North Hertfordshire District Council

Building Conservation comments

File Ref: 24/02424/FPH & 24/02425/LBC

Address: 72 Tilehouse Street, Hitchin, Hertfordshire, SG5 2DY

HET 1614/01 Rev A
20/01231/FPH & 20/01232/LBC

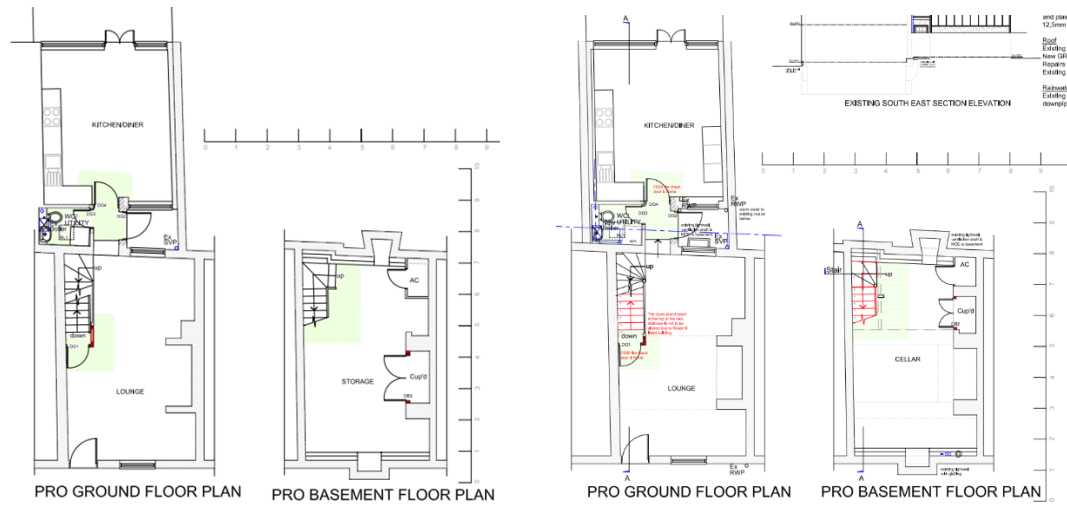
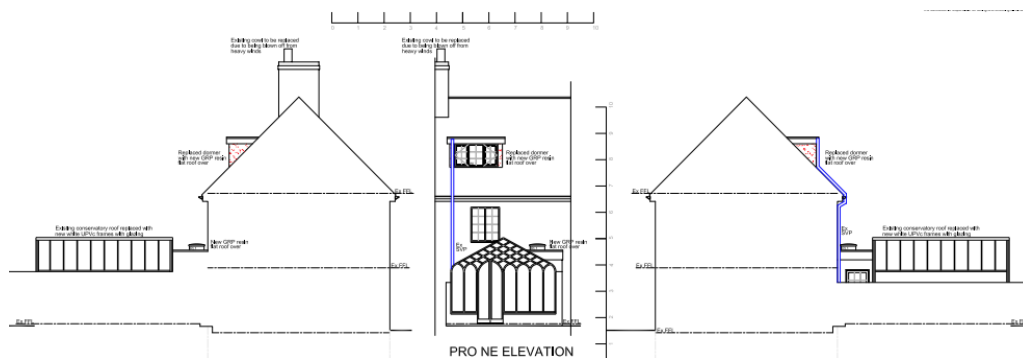
3.1 With these applications essentially being renewal cases (see comparison on next page), one would normally consider carrying conditions across as previously worded. The only difference here is that new plan numbers have been given: HET 1614/01 Rev A is now HET 1614/10 Rev A and HET 1614/02 Rev A is now HET 1614/11 Rev A. To keep the numerical order of the plans I would reverse Conditions 2 and 3 as follows:

2. Notwithstanding approved drawing no. HET 1614/10 Rev A, the down-stand beam in the basement in the vicinity of the top of the new basement staircase shall not be altered unless otherwise agreed and approved in writing by the Local Planning Authority.

HET 1614/11 Rev A

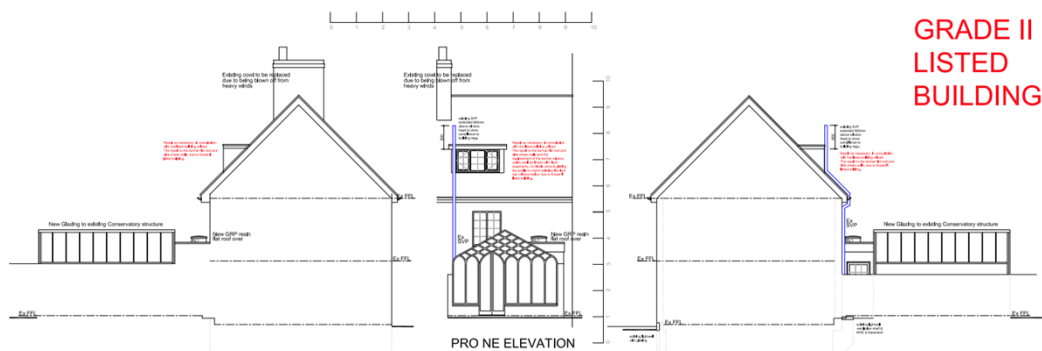
3. Notwithstanding approved drawing no. HET 1614/11 Rev A, the new windows to the replacement dormer shall be manufactured in timber with flush casements and no trickle vents and the glazing bar profile shall match as closely as possible that of the glazing bars to the first floor window on the rear elevation unless otherwise agreed and approved in writing by the Local Planning Authority.
